**New Field Safety Notice - Urgent Medical Device Correction**  
**da Vinci® 5 (dV5) System equipped with the Near Infrared (NIR)**  
**Handheld Camera (ISIFA2026-03-C)**

<p>1- Introduction and Reason for Field Action</p>	<p>Dear Intuitive Customer,</p> <p>This Field Safety Notice (FSN) is to advise you that Intuitive is initiating a Field Safety Corrective Action (FSCA) for the da Vinci® 5 (dV5) System equipped with the Near Infrared (NIR) Handheld Camera.</p> <p>The NIR Handheld Camera system is intended to be used for laparoscopic tasks within da Vinci procedures.</p> <p>Intuitive has identified a condition in which the NIR modes may remain active unintentionally when attempting to turn off visible white light illumination during normal clinical workflow transitions, notably when switching from the handheld camera to the robotic endoscope, which may result in thermal injury if the distal end of the light guide (detached) or assembled laparoscope contacts the patient, user, or sterile drapes while NIR mode is active.</p> <p>Due to the Camera Head button functionality, users may assume that they have turned off all illumination when the system is actually still operating in a nea

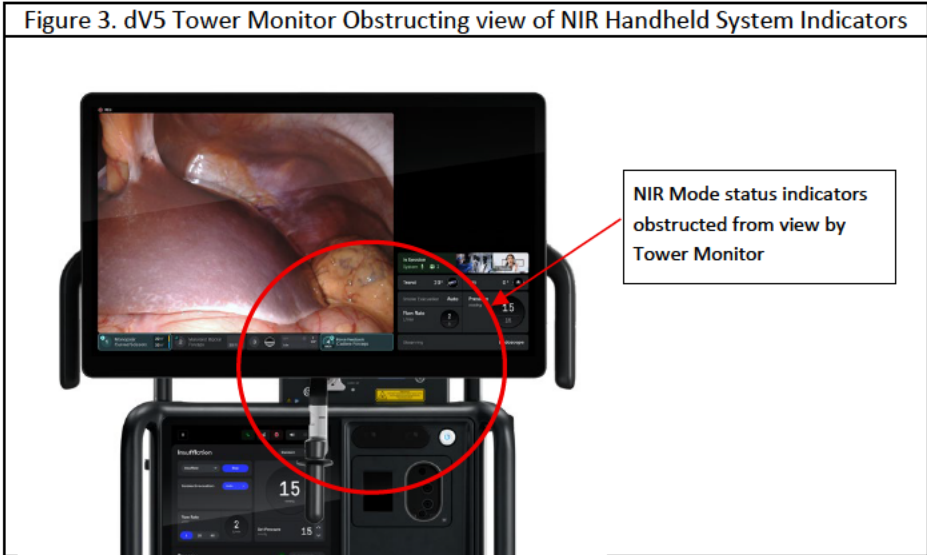
<p>Figure 3. dV5 Tower Monitor Obstructing view of NIR Handheld System Indicators</p> 
<p>2 - Risk to Health</p>	<p>At this time, Intuitive has received forty-two (42) potentially relevant complaints worldwide. No serious incidents* associated with this issue were reported in Europe.</p> <p>Unintended activation of the NIR modes may result in external patient or user burn injury due to localized heating if the detached light guide cable is placed on the patient or sterile drapes while the NIR mode is active. Burn severity may range from minor superficial burns requiring minimal treatment to more serious burns requiring medical or surgical intervention.</p> <p>Localized heating may also damage or create holes in sterile drapes, potentially compromising sterility and increasing the risk of contamination and infection, which in severe cases could require medical or surgical treatment.</p> <p>Contact between the high-temperature distal tip of the light guide cable and flammable materials could result in ignition and / or combustion of those materials.</p>

- The indicators include:
  - “LASER ON” status indicator
  - Laser symbol on the LCD display
  - Green-colored button backlights
- Refer to the Near Infrared Handheld Camera System User Manual (PN 557076-03) for recommended placement of the NIR Handheld Camera system components.

Figure 4. Placement of CCU and light source (example)

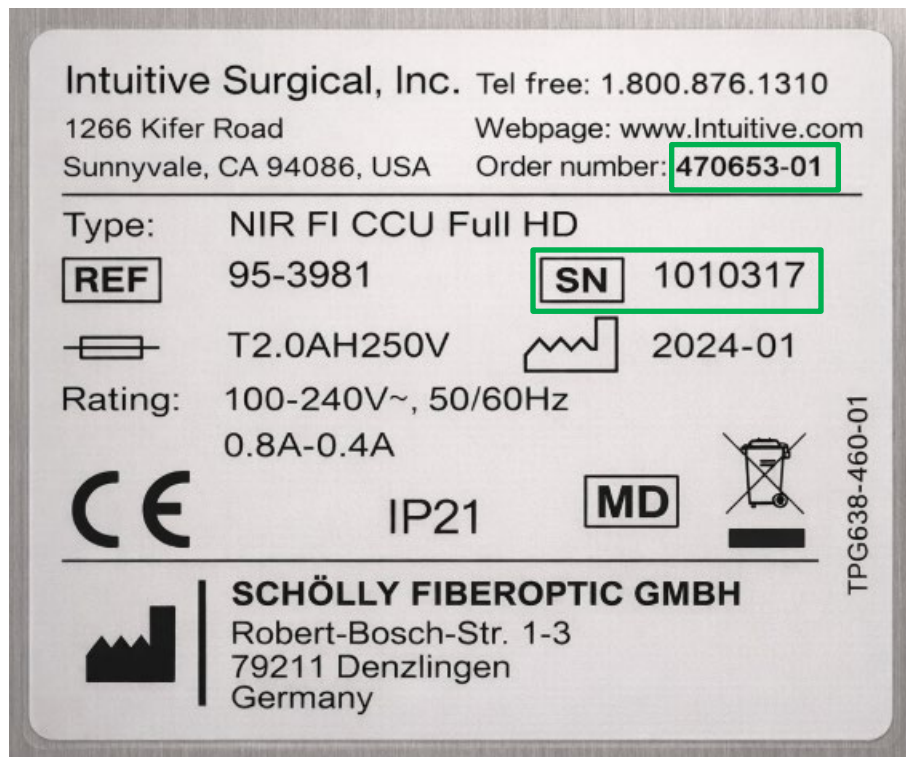
1. **Tower monitor:** Images are displayed on this monitor.
2. **NIR handheld camera control unit (CCU):** Placed atop the NIR handheld camera light source.
3. **NIR handheld camera light source:** Placed on the accessory shelf of the Tower.
4. **Tower touchscreen:** Used to modify display settings.
